NRC DOCKETS 50-321, 50-306
OPERATING LICENSES DPR-57, NPF-5
EDWIN I. HATCH NUCLEAR PLANT UNITS 1, 2
RESPONSE TO NRC REQUEST FOR ADDITIONAL
INFORMATION - INSERVICE INSPECTION PROGRAM

RESPONSE TO NRC REQUEST OF DECEMBER 23, 1985
FOR ADDITIONAL INFORMATION ON HATCH
UNITS 1 AND 2 INSERVICE INSPECTION PROGRAM UPDATE

FIGURE 1

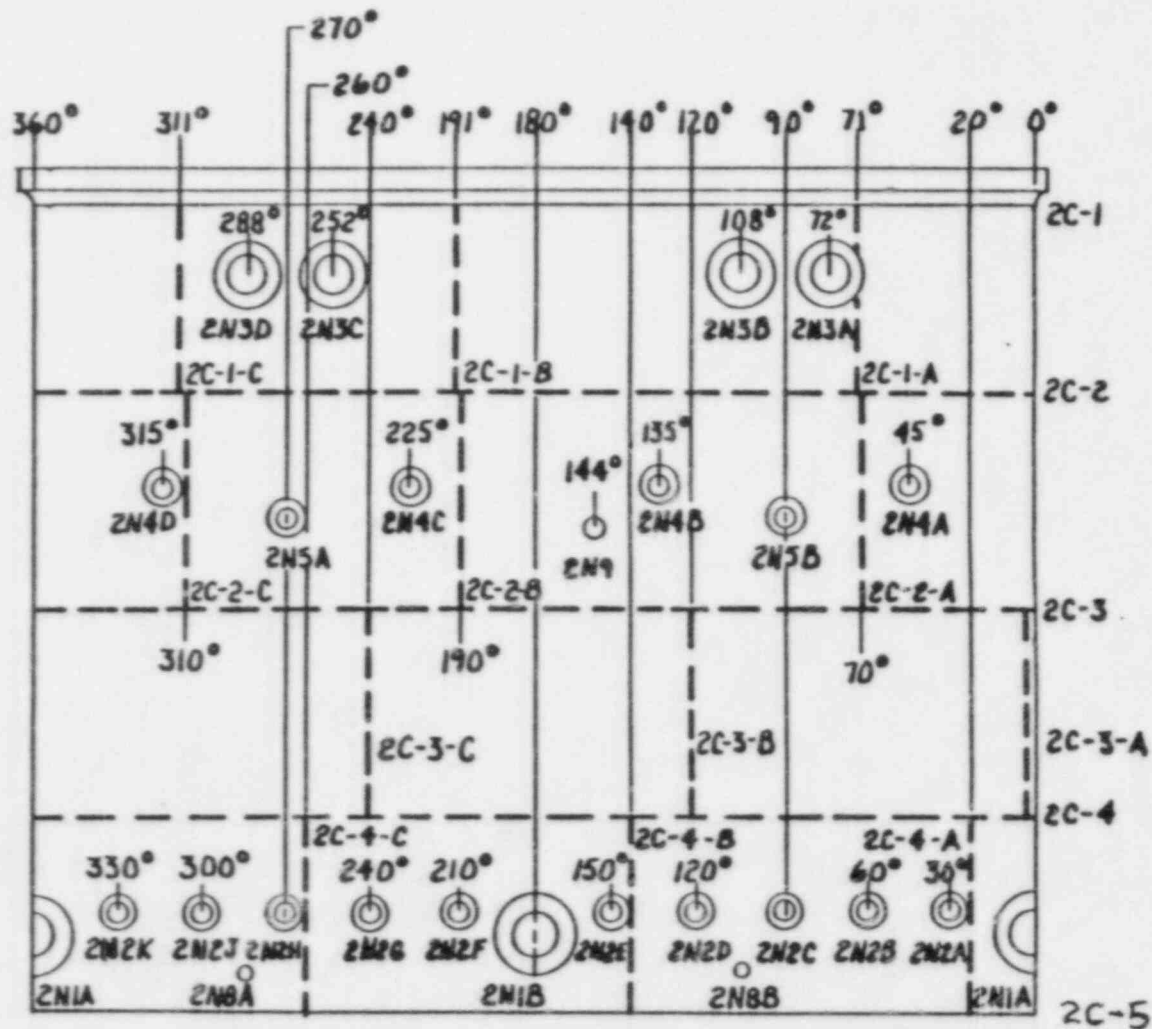
You have requested relief (ISI Plan Section 2.1.1) from the requirements of performing a 100% volumetric examination of reactor pressure vessel and closure head welds, item numbers B1.11, B1.12, B1.21, and B1.22 of Table IWB-2500-1. The contents of your relief request indicate that you may be attempting to examine the accessible portions of all vessel and head welds.

- (a) Identify one weld for each code item number to be examined; also specify the percentage of the weld accessible for examination. Give a complete description of the reason why 100% of the weld length cannot be examined (i.e., describe physical limitations).

- (b) For welds listed in (a) above that will not receive a 100% examination, define additional welds of the same code item number (B1.11 and B1.12 must be beltline welds) that can be examined as an alternative to the code requirement. Choose enough welds such that the total weld length examined, to the extent of available welds, equals the length of the weld defined in (a) above.

You have requested relief (ISI Plan Section 2.1.3) from the requirement of performing a 100% volumetric examination of certain nozzle-to-vessel welds and nozzle inside radius sections. Please provide the following information:

Item B1.11 - Hatch Unit 1 - There are two circumferential welds (C-3 and C-4) in the beltline region of the RPV as shown in Figure 1. Weld C-4 has three access doors through the concrete shield, and removable RPV insulation in these areas was provided during the design. These three access ports allow the manual examination of approximately 15% of the weld. Weld C-3 has two usable access doors allowing approximately 10% coverage; therefore, a total of only 25% of the beltline area welds can be examined during the second 10-year interval.

Item B1.12 - Hatch Unit 1 - Using the same access doors as described above, approximately 20 to 30% of C-3-A, 20 to 30% of C-3-B, and 10 to 15% of weld C-3-C can be manually examined. Therefore, a total of 50 to 75% of the beltline longitudinal welds can be examined during the second 10-year interval. Also, during the second 10-year interval, sufficient weld lengths will be selected from welds C-2-A, C-2-B, C-2-C and/or C-4-A, C-4-B, and C-4-C to ensure that the equivalent length of one beltline longitudinal weld is examined. Examinations will be scheduled to allow partial coverage of the total scope each 40-month period.

Item B1.21 - Hatch Unit 1 - Circumferential bottom head weld C-7 (Figure 1) will be 100% examined to the extent practical during the second 10-year interval. If it is found during examinations that 100% coverage cannot be obtained, specific relief will be requested at that time. One circumferential closure head weld will also be 100% examined during the interval.

Item B1.22 - Hatch Unit 1 - One of the bottom head meridional welds extending from circumferential weld C-5 to C-7 (Figure 1) will be 100% examined to the extent practical during the interval. If it is found during examinations that 100% coverage cannot be obtained, specific relief will be requested at that time. One meridional closure head weld will also be 100% examined during the interval.

Examination limitations exist for the nozzle examinations at Hatch Units 1 & 2 due to a combination of permanent physical obstructions. At Hatch Unit 1 an insulation support ring (Figure 1) is welded just above the N2A through K Recirculation System Inlet Nozzles and the N1A and B Recirculation System Outlet Nozzles. Welded thermocouples are near nozzles N4B and N4D which partially limit coverage. These limitations exist regardless of transducer size. Hatch Unit 2 has limitations for the examination of the 2N4A and C Feedwater Nozzles due to interference from adjacent nozzles (Figure 2) and the transition area of the nozzles where they are welded to the shell. As before, transducer size has very little impact on the coverage of these feedwater nozzle welds. Showing the Nozzle-to-Vessel weld as N to V and the Nozzle Inside Radius Section as IRS, the table below shows the affected nozzle, minimum coverage, and reason for limitation.

FIGURE 3

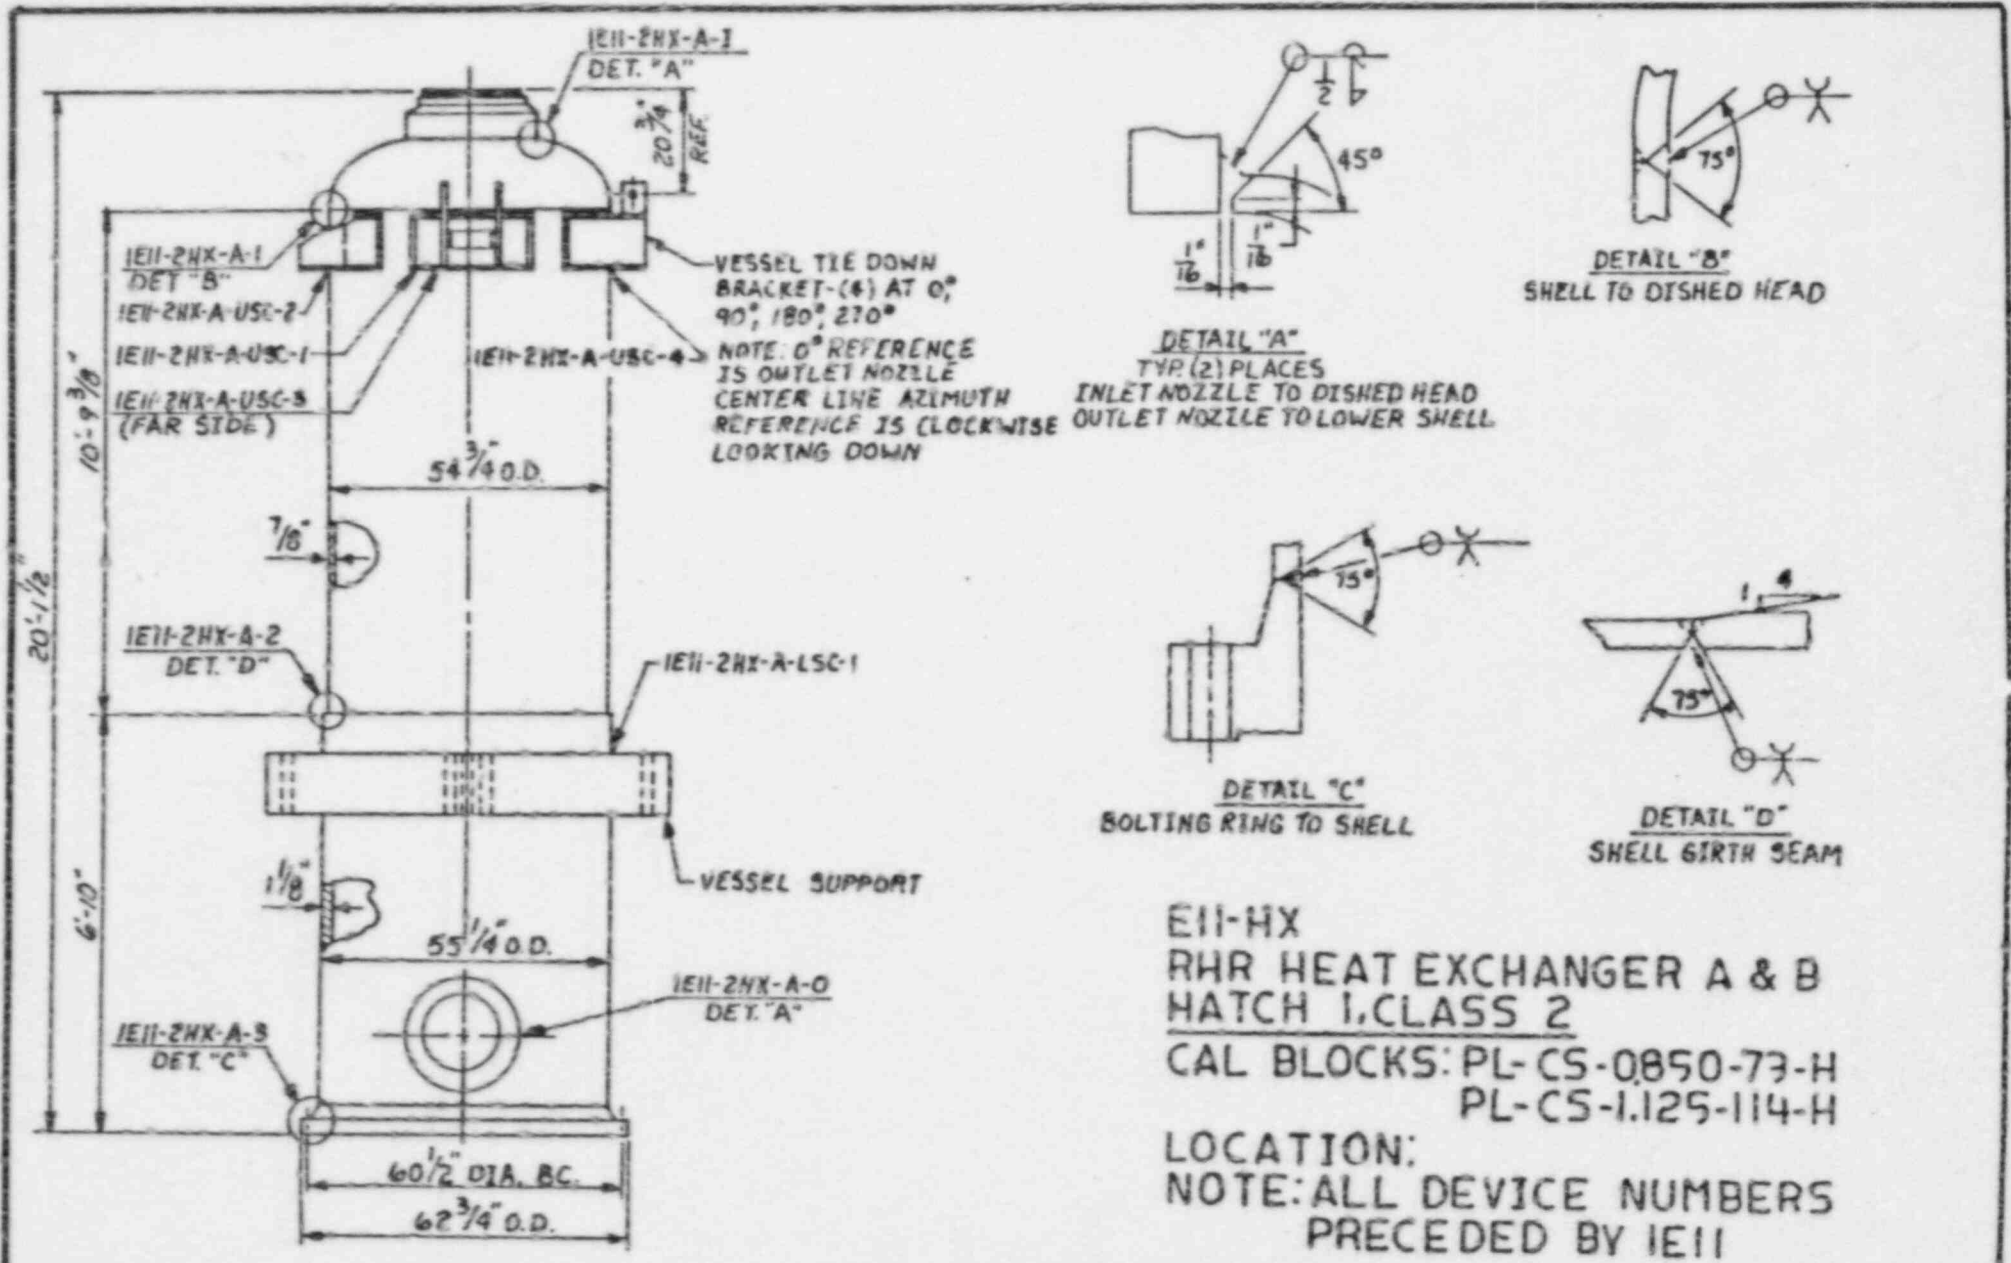
You have requested relief (ISI Plan Section 3.1.1) from the requirements of performing a 100% volumetric examination of the residual heat removal (RHR) heat exchanger Class 2 vessel shell, head, and tubesheet-to-shell circumferential welds. Please provide the following information:

- (a) Define the percentage of the volumetric examination for each weld that will receive a partial volumetric examination.
- (b) Sketches showing the vessel supports interfering with the RHR shell and head circumferential weld examination. Provide all appropriate dimensions and include enough information about the examination equipment to enable verification of the interference with the examination equipment.
- (c) Sketches showing the design configuration that prohibits examination of the head circumferential weld and the tubesheet-to-shell weld. Provide all appropriate dimensions, including the ultrasonic transducer, to enable verification of the interference.

There are three Category C-A circumferential welds in each of the two RHR heat exchangers. These welds and their UT limitations are given below. (See attached Figure 3).

- 2E11 - 2Hx-A(B)-1 Shell Head to Upper Shell Ring - These welds cannot be examined from the shell head side due to the curvature of the head. Only about 65" of a total circumference of 179" (approximately 36%) can be examined from the Upper Shell Ring side due to support interference.
- 2E11 - 2Hx-A(B)-2 Upper Shell Ring to Lower Shell Ring - Complete coverage is obtained from the Upper Shell Ring side and approximately 36% coverage from the Lower Shell Ring side due to support interference.
- 2E11 - 2Hx-A(B)-3 Lower Shell Ring to Flange - Complete coverage is obtained from the Lower Shell Ring side. Examination from the flange side cannot be performed due to the geometry.

FIGURE 5

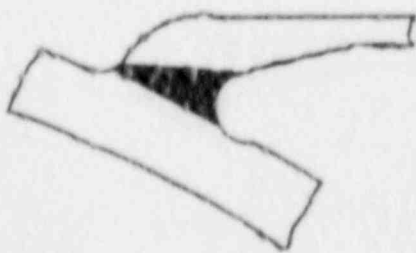
You have requested relief (ISI Plan Section 3.1.3) from the requirement of a surface examination of Class 2 pump casing welds. You justified your relief request based on the exposure to radiation from the disassembly of these pumps to perform the surface examination.

- (a) The Code allows surface examinations of Class 2 pump casing welds to be performed from the inside or outside surface of the pump. Is there a reason why the examination can not (sic) be performed from the outside surface?
- (b) If the examination cannot be performed from the outside, you should provide an estimate of the total radiation exposure received in performing the required examination from the inside surface of the pump.

This relief request applies to the Core Spray Pumps and RHR Pumps on Hatch Unit 2 only. The Hatch Unit 1 pumps have a different design and do not contain pressure retaining welds (Item No. C6.10). As shown in Figure 5, the pressure retaining welds 2E11-2RHR-PLP-A-1 thru 6 are completely encased in the suction casing and can be accessed only when the pump is completely disassembled. These welds are not the welds considered to be pressure retaining pump casing welds; therefore, it is impractical to disassemble just to examine these welds. (Note: At least one of the six pumps has been disassembled for maintenance and the welds examined).

FIGURE 7

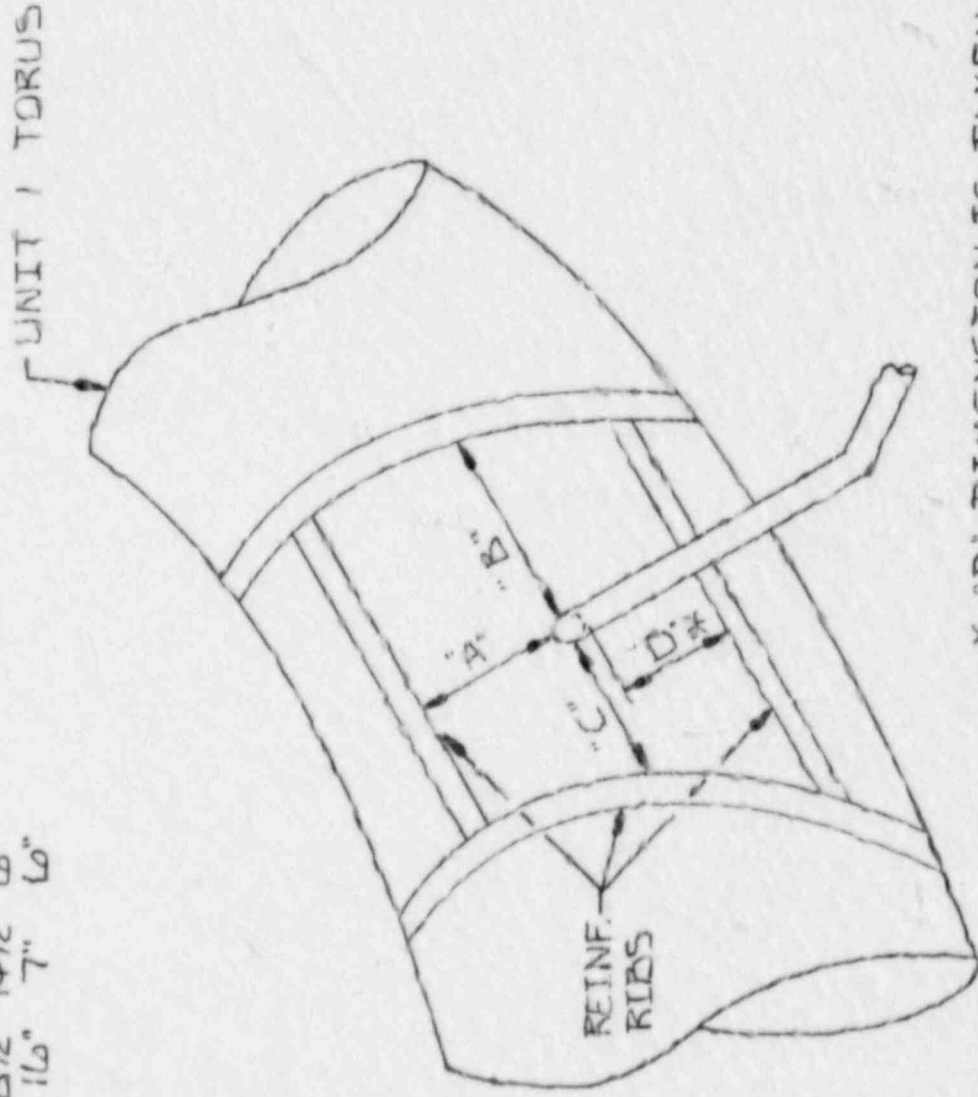
You have requested relief (ISI Plan Section 3.1.2) from the requirements of a surface examination of integrally welded attachments on RHR, Core Spray, HPCI, and RCIC suction lines from the Torus. You stated that the welds requiring examination are covered by reinforcement plates and that they will be examined by visual examination. Please provide the following information concerning the reinforcement plates:

- (a) Are the reinforcement plates welded to both the Torus and piping?
- (b) Can the welds attaching the reinforcement plates be surface examined?
- (c) Provide sketches showing attachment of reinforcement plate to Torus and to pipe. Indicate extent of welds to be examined.

As shown in Figure 7, the suction piping is surrounded by reinforcing ribs which may limit access on one or more sides of the pipe, in particular, when using magnetic particle techniques. This method is preferred since the torus has a heavy coating of paint, and removing the paint and cleaning the surface to perform penetrant examinations would be extremely difficult with the space limitations. As shown in Figure 7 approximately 80-100% of the RCIC (1E51) and HPCI (1E41) welds can be examined, approximately 50-75% of the Core Spray (1E21) welds, and approximately 25% or less of the RHR (1E11) welds.
